DODGE 48RE VALVEBODY HYDRAULIC DIFFERENCES

CHANGE: Beginning at the start of production for the model year 2003, the 48RE transmission was introduced to the Dodge line of Heavy Duty trucks. The 48RE is a new designation for the previous design 46/47RE. There are numerous differences as far as a re-designed pump Stator and Torque Converter as well as increased capacity in the clutch drums. There was also a change in the hydraulics in the Valvebody in the Torque Converter Clutch Control circuit.

46RE /47RE MAIN SPACER PLATE

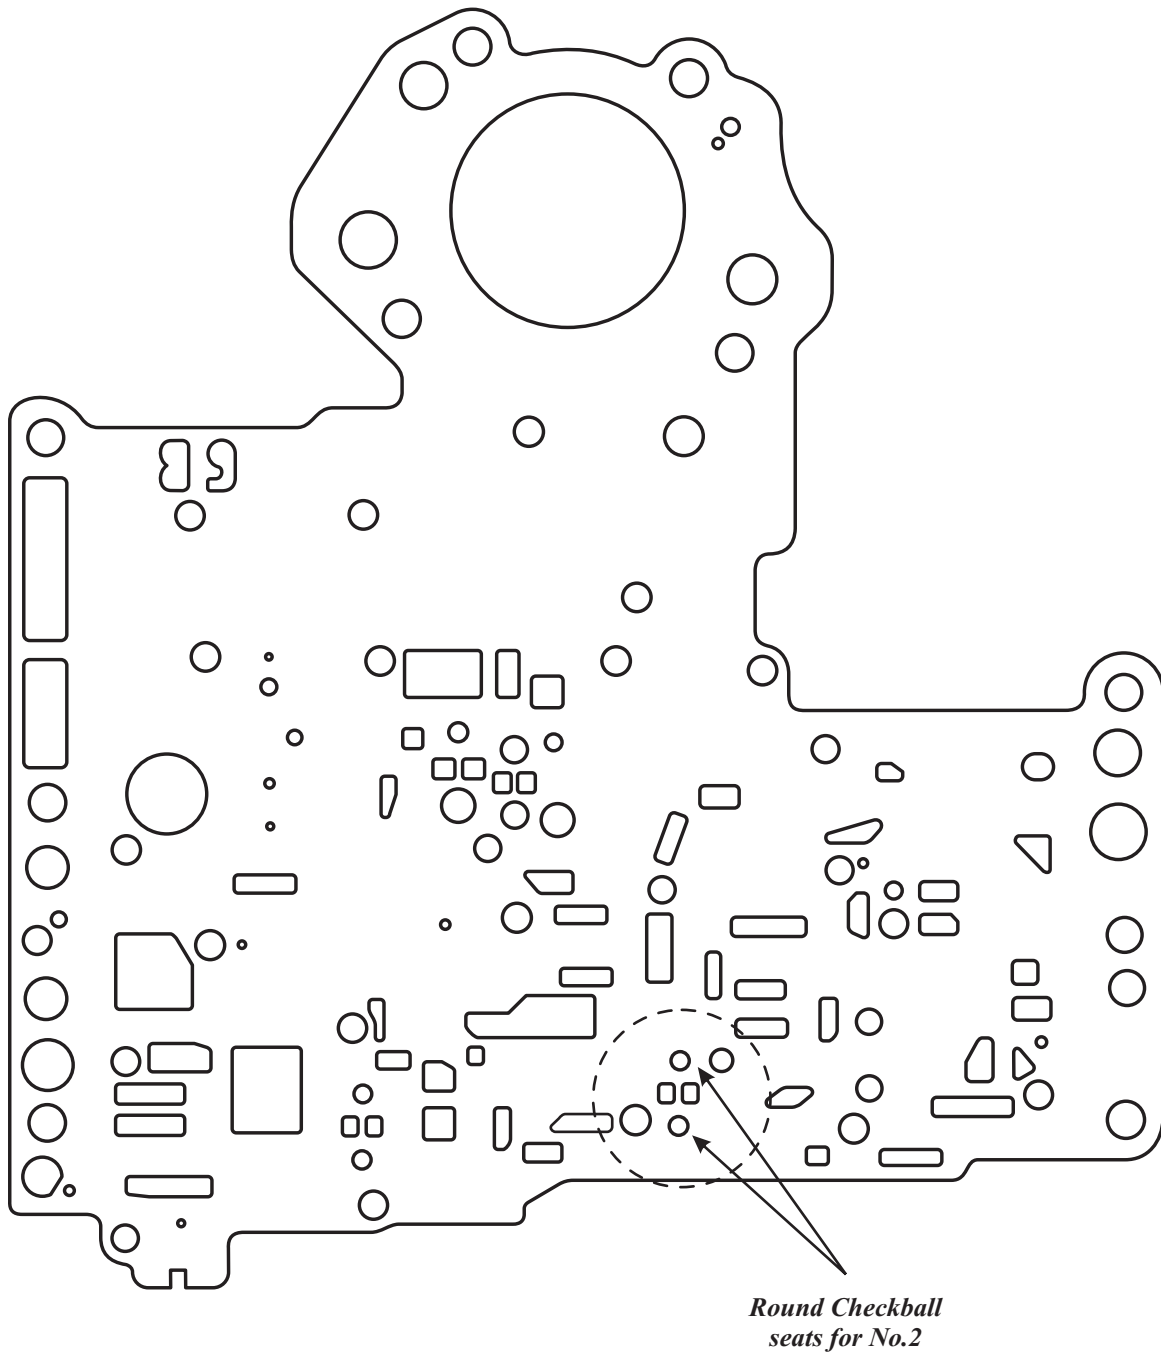
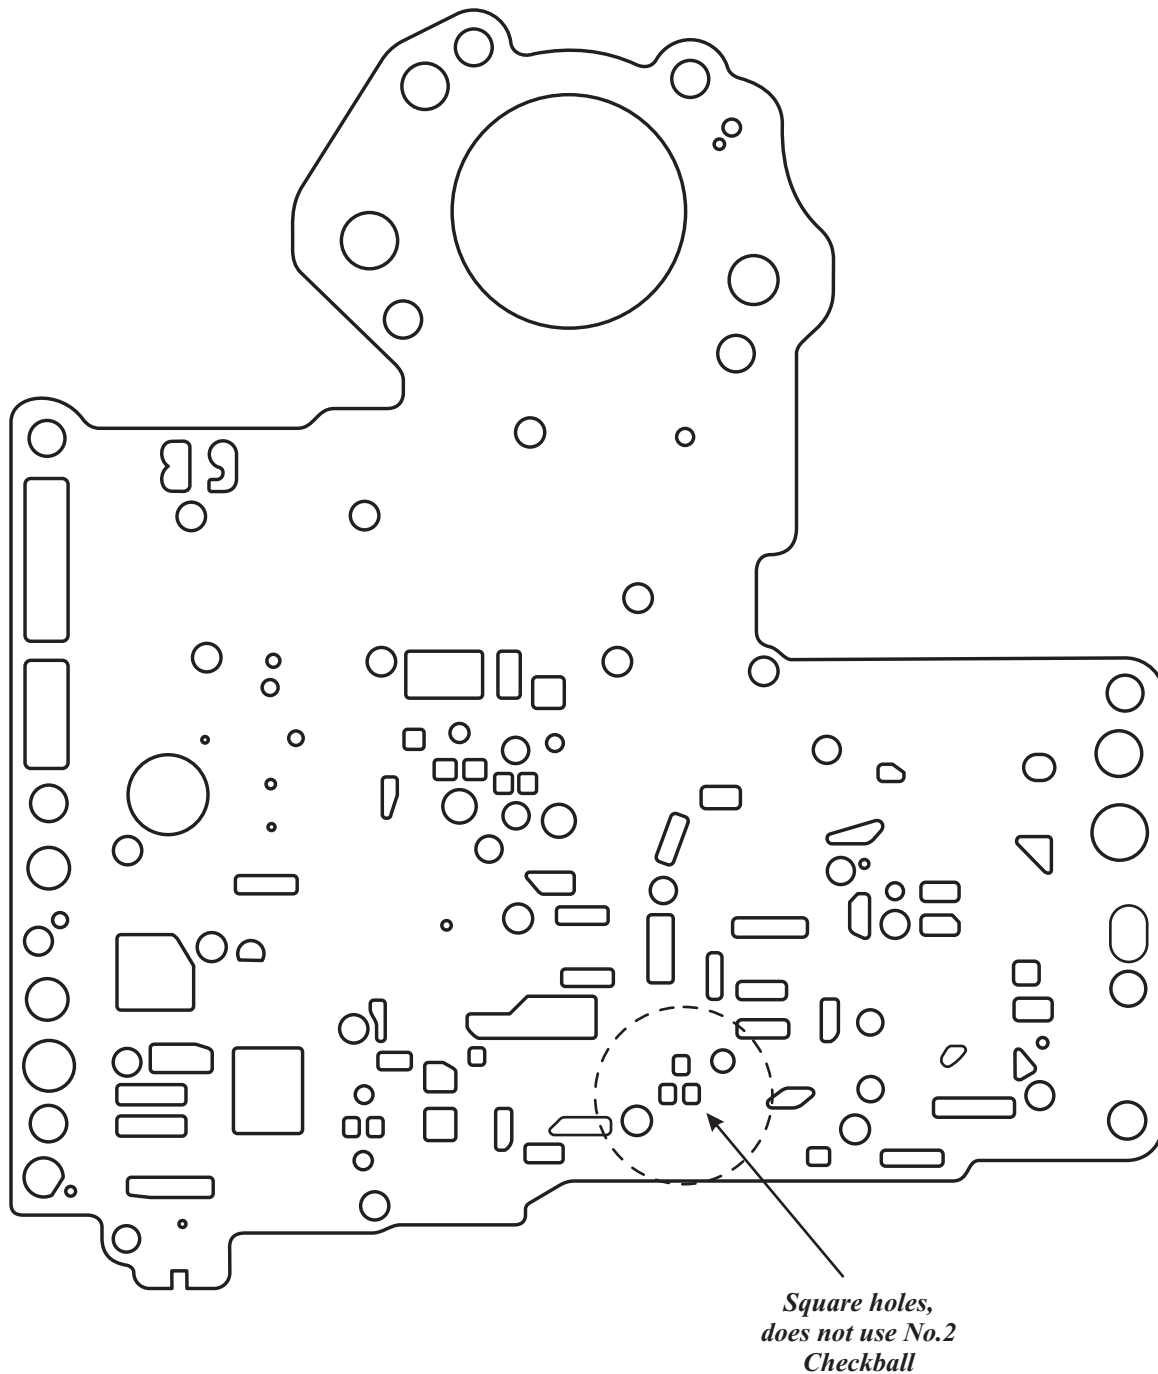
Refer to Figure 4 for a view of the Main Spacer Plate on the 46RE/47RE, and the hole configuration for the Number 2 checkball.

Refer to Figure 7 for a view of the Main Spacer Plate on the 48RE, and the hole configuration for where the Number 2 checkball used to be. Notice there are only 3 holes, which are square, when compared to the previous plate in Figure 4.

46RE /47RE TRANSFER AND SPACER PLATE "LOWER-SIDE"

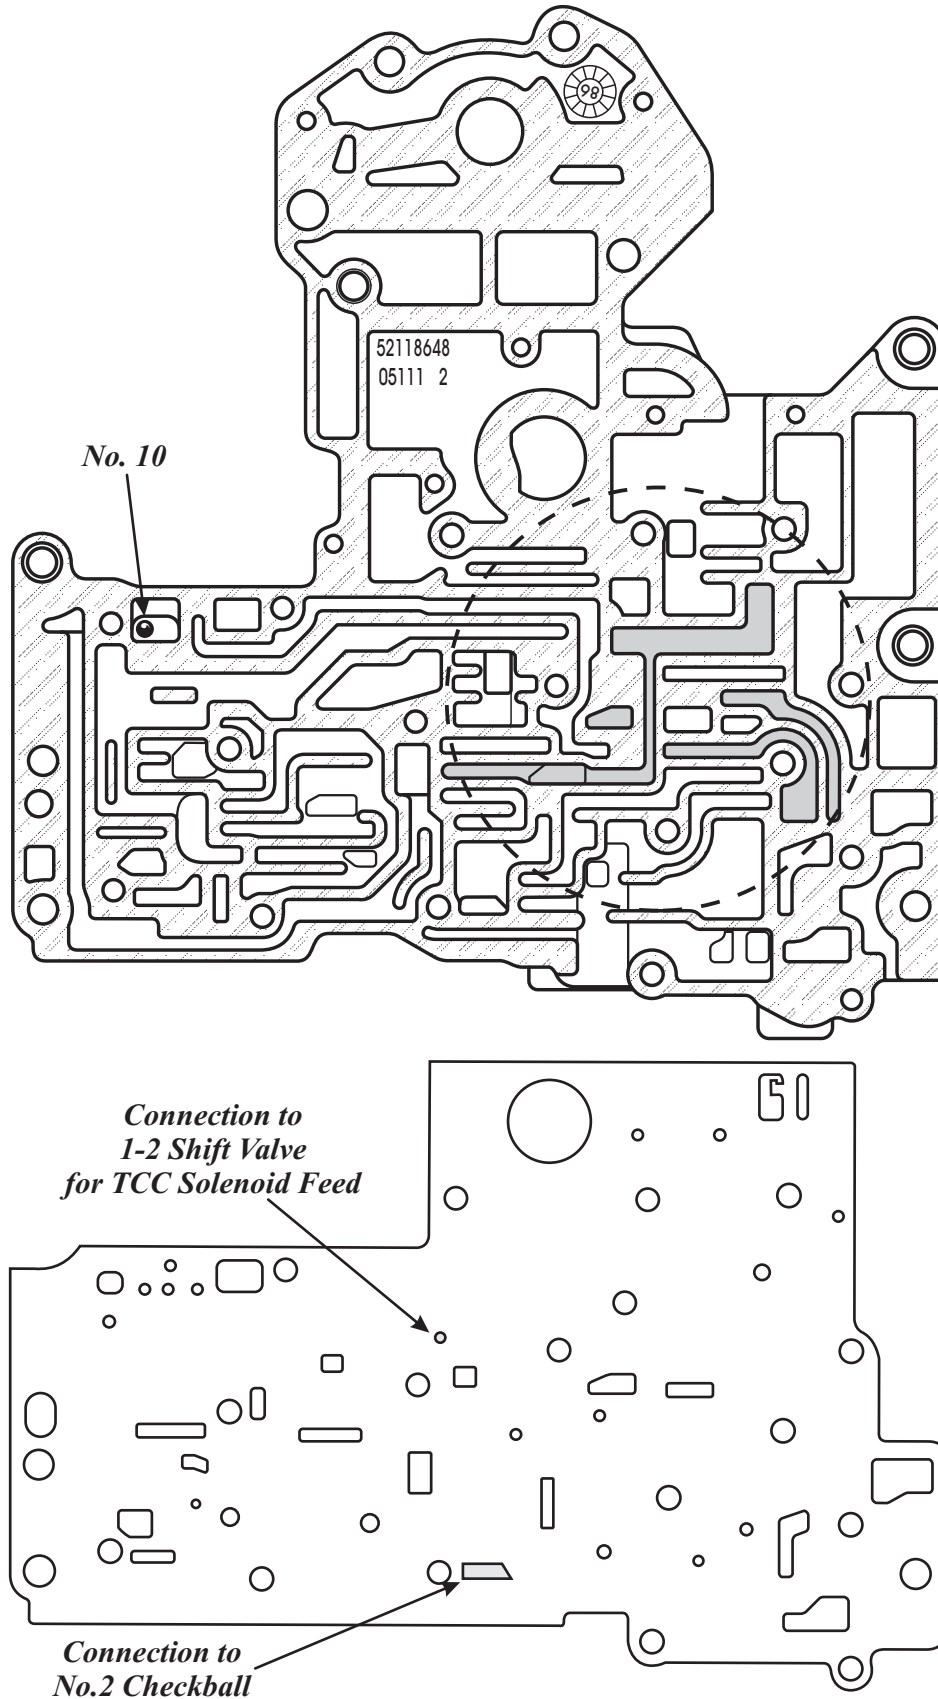
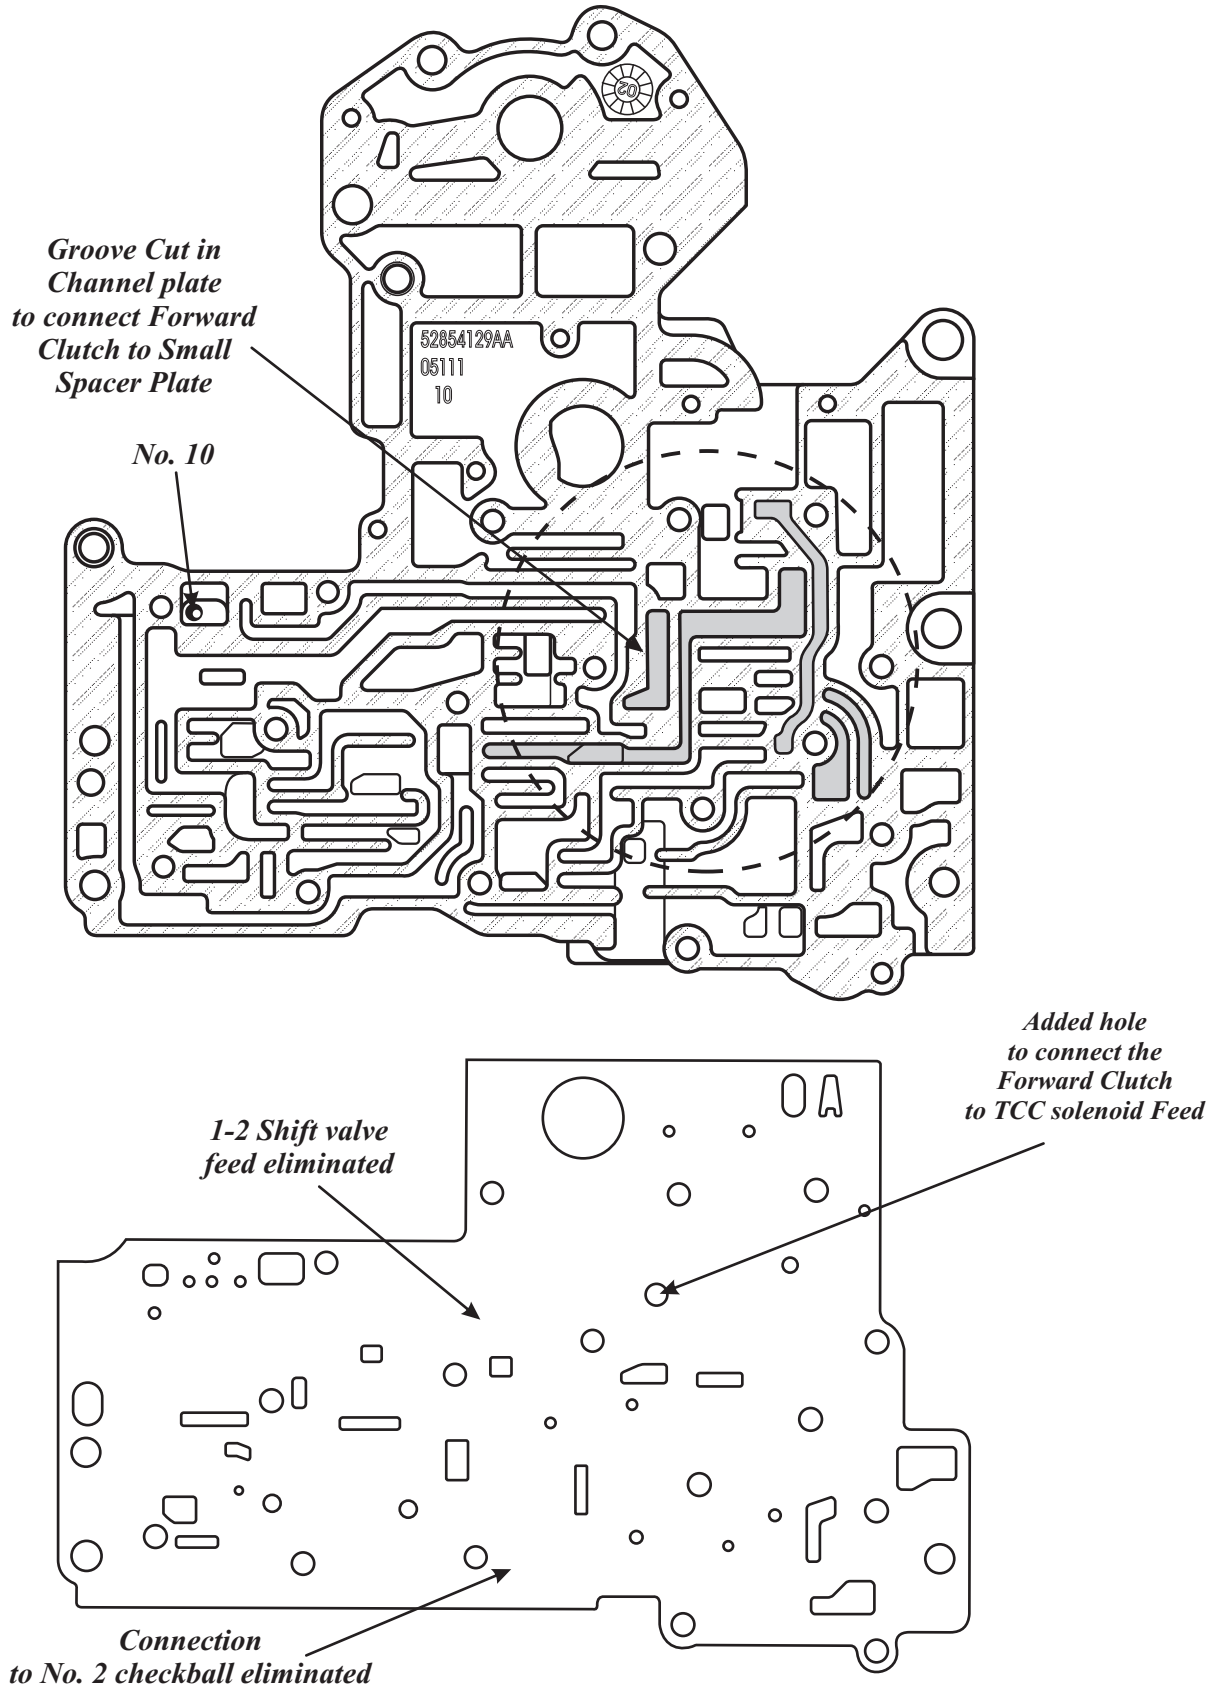
Refer to Figure 5 for a view of the Lower Transfer Plate and Lower Spacer Plate on the 46RE/47RE, and the hole configuration for the Number 2 checkball to the spring side of the Lock-up and 3-4 Shift Valve, and second land of the Lock-up Timing Valve. Also Figure 5 shows the Previous design TCC solenoid feed from the 1-2 shift valve.

Refer to Figure 8 for a view of the Lower Transfer Plate and Lower Spacer Plate on the 48RE, and the hole configuration for the Number 2 checkball is eliminated. Also Figure 8 shows the Previous design TCC solenoid feed from the 1-2 shift valve has been eliminated and the new hole connects the slot in the channel plate to the Forward Clutch circuit.
